Project	IEEE 802.16 Broadband Wireless Access Working Group < http://ieee802.org/16 >	
Title	Changes on Downlink and Uplink Resource Allocation in OFDMA-PHY	
Date Submitted	2004-01-15	
Source(s)	Chulsik Yoon, Jaeheung Kim, Kunmin Yeo, Soonyong Lim, Byunghan Ryu ETRI 161 Gajeong-Dong, Yuseong-Gu, Daejeon, Korea	Voice: +82-42-860-6826 Fax: +82-42-860-6732 mailto: csyoon@etri.re.kr
Re:	This is a response to a Call for Comments IEEE 802.16e-03/58 on IEEE 802.16e-03/07r5	
Abstract	This document contains more efficient downlink and uplink resource allocation method in OFDMA-PHY for mobility support applications.	
Purpose	The document is submitted for review by 802.16e Working Group members.	
Notice	This document has been prepared to assist IEEE 802.16. It is offered as a basis for discussion and is not binding on the contributing individual(s) or organization(s). The material in this document is subject to change in form and content after further study. The contributor(s) reserve(s) the right to add, amend or withdraw material contained herein.

Changes on Downlink Resource Allocation in OFDMA-PHY for Mobility Support

2. Proposed changes on IEEE 802.16e-03/07r5

Figure 208a Example of the data region which defines the OFDMA allocation in the downlink

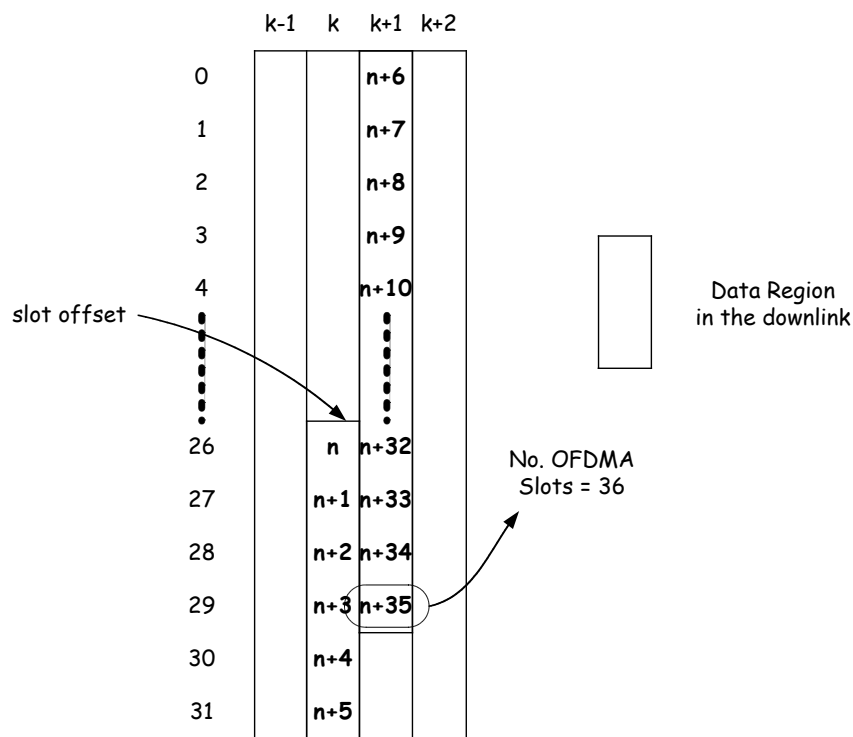
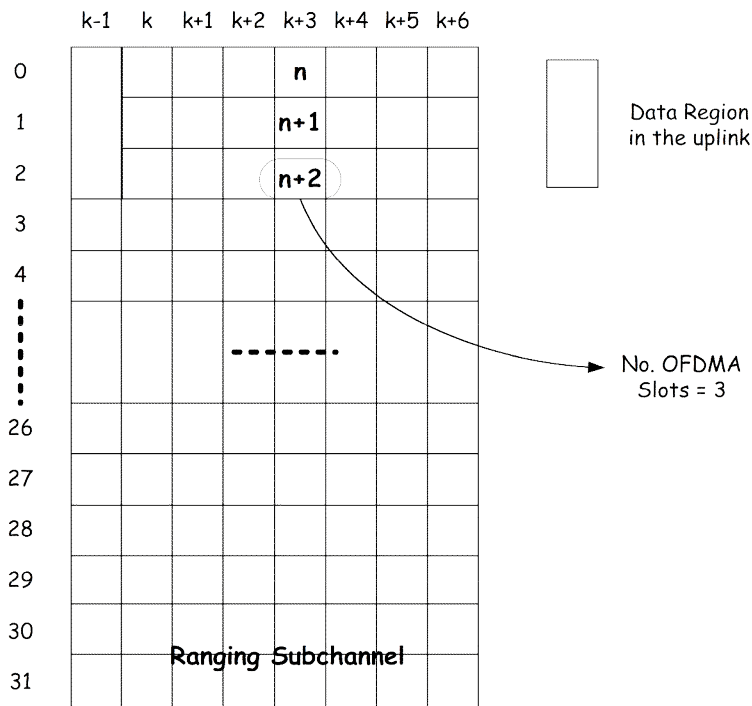
On the downlink allocation, an OFDMA slot is one subchannel by one OFDMA symbol for a regular subchannels, and one mini-subchannel by three OFDMA symbols for mini-subchannels. On the uplink allocation, an OFDMA slot is one subchannel (or minisubchannel) by the number of OFDMA symbols configuring the uplink subframe.

In OFDMA, a Data Region is an allocation of a group of contiguous sequence of slots, such as the block in Figure 208.

[Replace the Figure 208 to the following Figure 208a and 208b:]

Figure 209a Example of mapping FEC blocks to subchannels and symbols in the downlink when using mini-subchannels

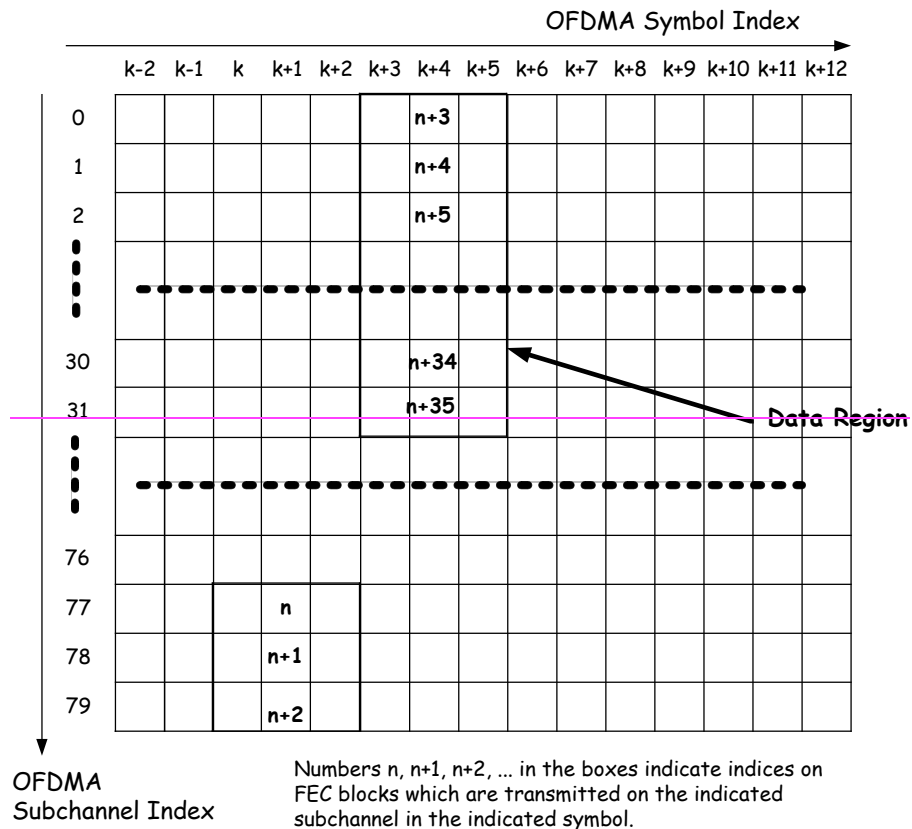
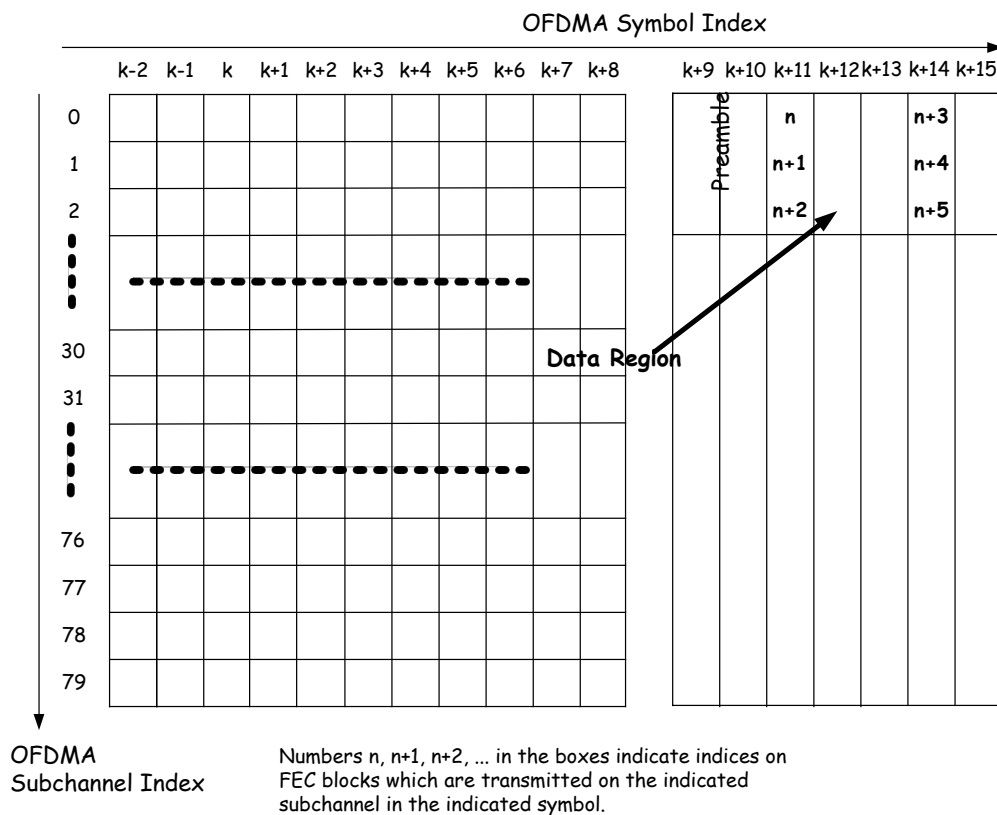
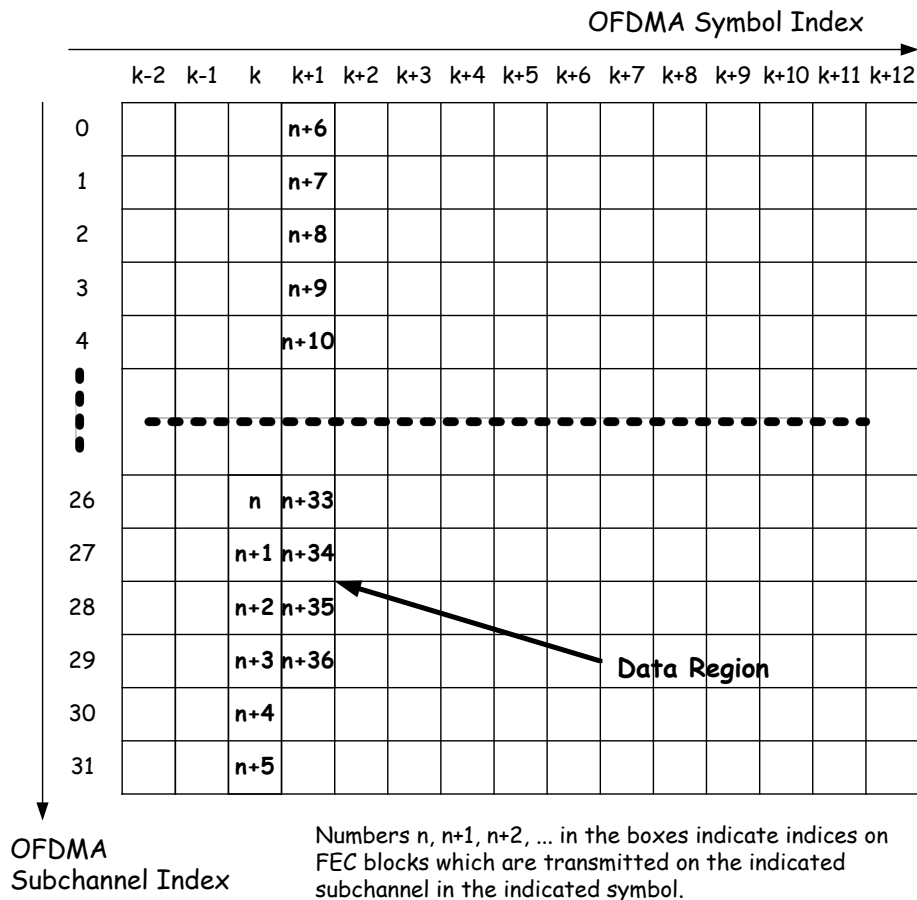
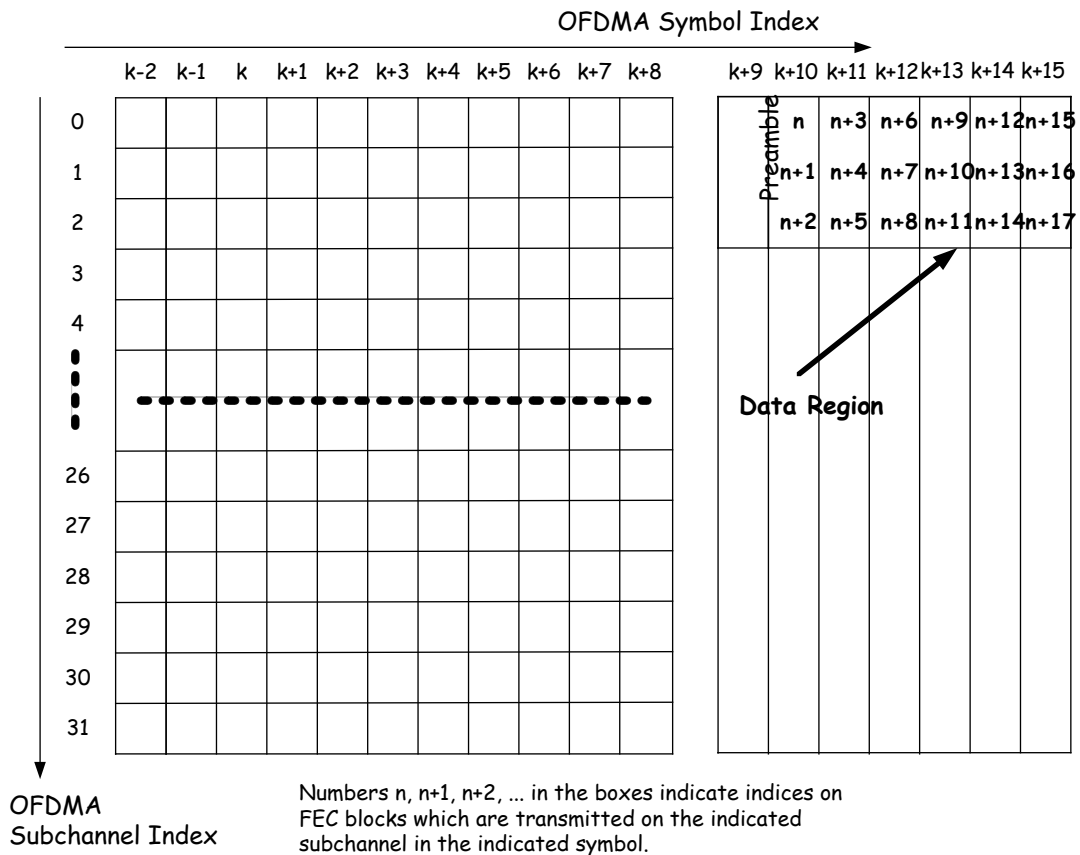
- 1) Segment the data into blocks sized to fit into one FEC block.
- 2) Each FEC block spans one subchannel in the subchannel axis and one OFDMA symbol in the time axis (see figure 210). In addition, when mini-subchannels are employed for the uplink direction, each FEC block spans three OFDMA symbols in the time axis (see Figure 209). Map the FEC blocks such that the lowest numbered FEC block occupies the lowest numbered subchannel in the lowest numbered OFDMA symbol.
- 3) Continue the mapping such that the subchannel index is increased for each FEC block mapped. When the edge of the Data Region is reached, continue the mapping from ~~the lowest numbered~~ subchannel number 0 in the next OFDMA symbol.

[Replace the Figure 209 and Figure 210 to the following Figure 209a, Figure 209b and Figure 210a, Figure 210b:]

Figure 211 Time plan – one TDD time frame

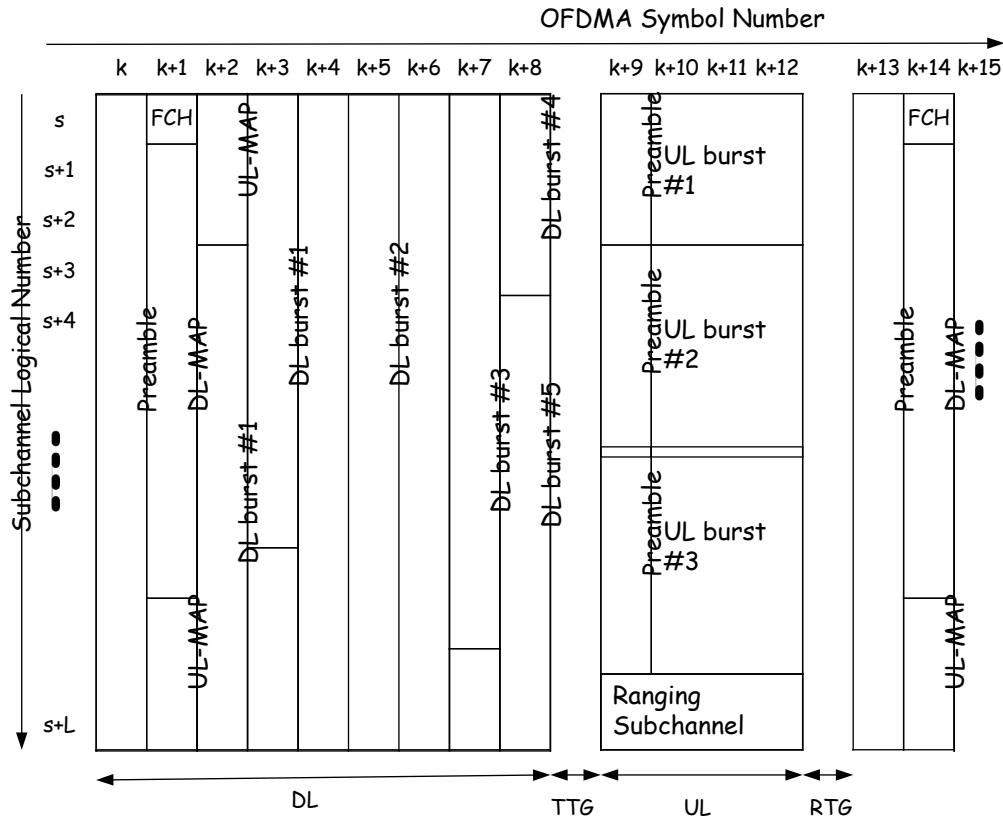
[Replace the Figure 211 to the following:]

The downlink bursts are transmitted in order of decreasing robustness. For example, with the use of a single FEC type with fixed parameters, data begins with QPSK modulation, followed by 16-QAM, followed by 64-QAM.
